STAFF REPORT

TO:	City Council
FROM:	Emily Becker, Planning Director
AGENDA ITEM:	Four Corners 2 nd Addition General Planned Unit Development (PUD) Concept Plan
REVIEWED BY:	Jack Griffin, City Engineer

To:Emily Becker, Planner DirectorRe:Four Corners 2nd Addition Concept Plan
(Commercial Site / Metro Transit Park & Ride)Cc:Chad Isakson, Assistant City EngineerFour Corners 2nd Addition Concept Plan
(Commercial Site / Metro Transit Park & Ride)From:Jack Griffin, P.E., City Engineer

RE: Washington County comments on Four Corners Second Addition, Proposed Concept Plan

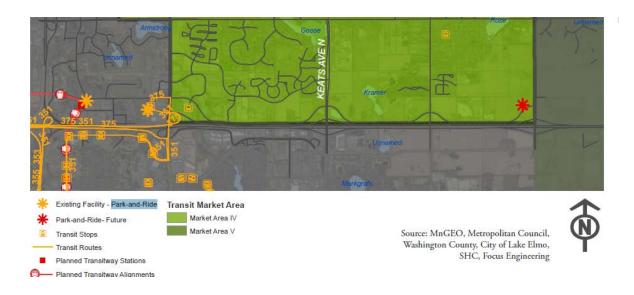
Site Plan. The proposed site plan includes one 6,800 square foot building financial building, 5,600 square foot restaurant, a 20,200 square foot gas station/convenience store, and a 10,400 square foot daycare along with 154 parking spaces, including 6 handicap parking spaces, within Outlot B. Outlot C includes a park and ride that will provide approximately 550 parking spaces, including 12 handicap parking spaces; electric charging stations; bike racks with overhead canopy; two 6'X13' bus shelters; 10.5'X12' restroom building. There is no current proposal for Outlot D. Outlot A will remain an outlot.

• *Interior Parking Lot Landscaping*. At least 5% of the interior area of parking lots with more than 30 spaces is required to be devoted to landscape planting areas, which may consist of islands or corner beds. It is unclear from the site plan what percentage is devoted to this on both Outlots B and C. Additionally, a minimum of 1 shade tree per 15

spaces within parking lots that total 101 spaces or more are required to be located within these corner islands or beds. With the proposed 550 parking spaces of the park and ride (Outlot C) a minimum of 37 shade trees are required to be provided within these corner beds or islands. The 154 parking spaces within Outlot B would require a minimum of 11 shade trees.

- Streets and Transportation
 - Hudson Boulevard Realignment. Hudson Boulevard must be realigned to move the existing Hudson Boulevard/Manning Avenue intersection north approximately 470 feet to align with the existing Holiday gas station, which the Concept Plan shows. This realignment must be designed meeting Municipal State Aid Design Standards for urban section roadways with a 45-mph design speed. Additional design details and geometrics are required for City review and changes to this realignment are likely needed.

- *Access.* There are three access points proposed along Hudson Boulevard, two of which meet spacing guidelines. The access to be shared by outlots B and C can only be permitted right-in/right-out, and a center median will be required.

It is a recommended condition of approval that the Preliminary Plat and PUD Plans submittal provide required interior and perimeter parking lot landscaping as required by the Zoning Code.
